RE: Newstan Colliery Modification 8 (DA 73-11-98) Response to Submissions

Set out below is Centennial Newstan's response to matters raised following public exhibition of the DA 73-11-98 Modification 8 Environmental Assessment (EA). A formal response to matters raised was requested by the Department of Planning and Environment (DP&E) in correspondence dated 26 October 2018.

Encl: Attachment 1: Summary and Response to Submissions
Attachment 2: Revised EA Figure 2-6
Attachment 3: Presentation Slides from the Northern Holdings ACHMP Sub-Committee on 9 May 2018

Attachment 2: Revised EA Figure 2-6

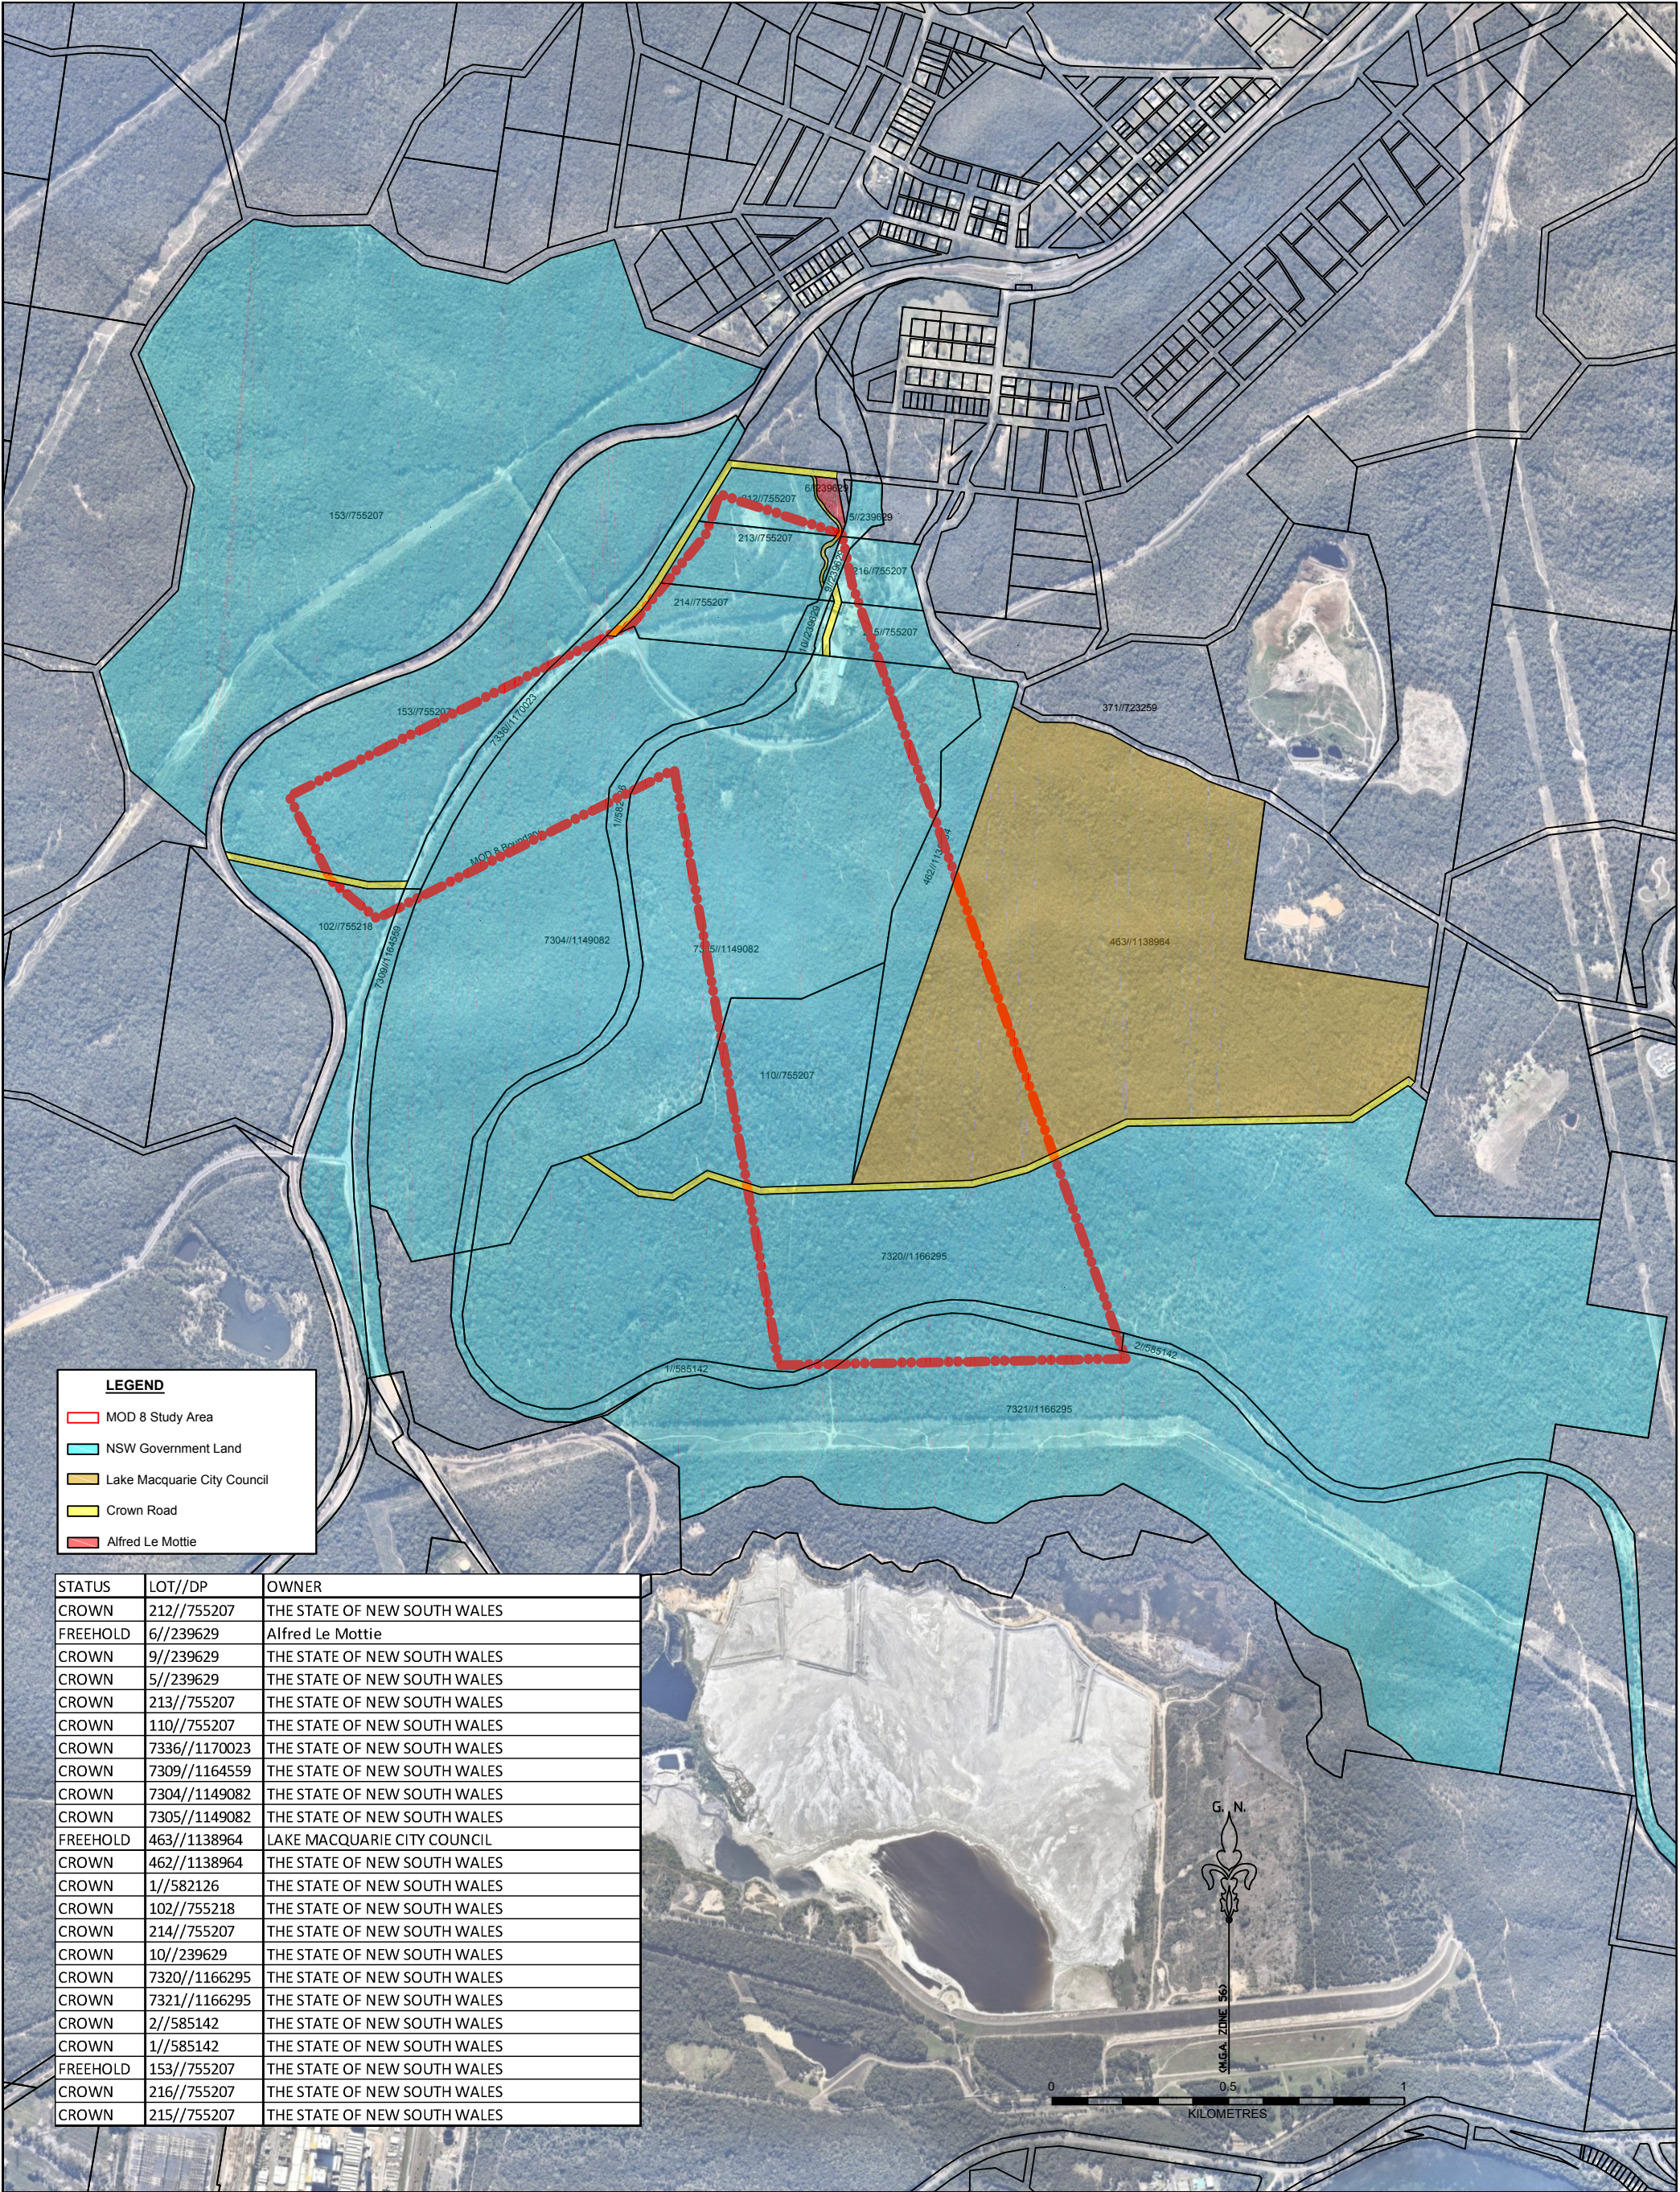
Submission matter: Land owned by Lake Macquarie City Council is partly within the project area. This land is described as Lot 463 DP 1138964 and is incorrectly shown in the environmental assessment (Figure 2-6) as being owned by the NSW Aboriginal Land Council. This land is known as the Awaba Biodiversity Conservation Area and is a biodiversity offset site managed for the protection of biodiversity in accordance with the Awaba Biodiversity Conservation Area – Plan of Management 2015. Council consulted with Centennial Coal in the preparation of this plan and Centennial Coal was made aware of the biodiversity significance of the site at that time.

Submission matter: Modification 8 is within the boundaries of the proposed Awaba Conservation Area and crosses the south- western corner of the Awaba Biodiversity Conservation Area (ABCA). LMCC has identified ABCA as an important and significant biodiversity high value area. Please find the ABCA Plan of Management in the attachments. On Page 13 of the Environmental Assessment, land ownership is incorrect for Lot 463 DP1138964.

Response: Centennial Newstan acknowledges this error on Figure 2-6 and has subsequently amended the figure. A copy is attached to this letter report as Attachment 2.

Response: Centennial Newstan acknowledges this error on Figure 2-6 and has subsequently amended the figure. A copy is attached to this letter report as Attachment 2.
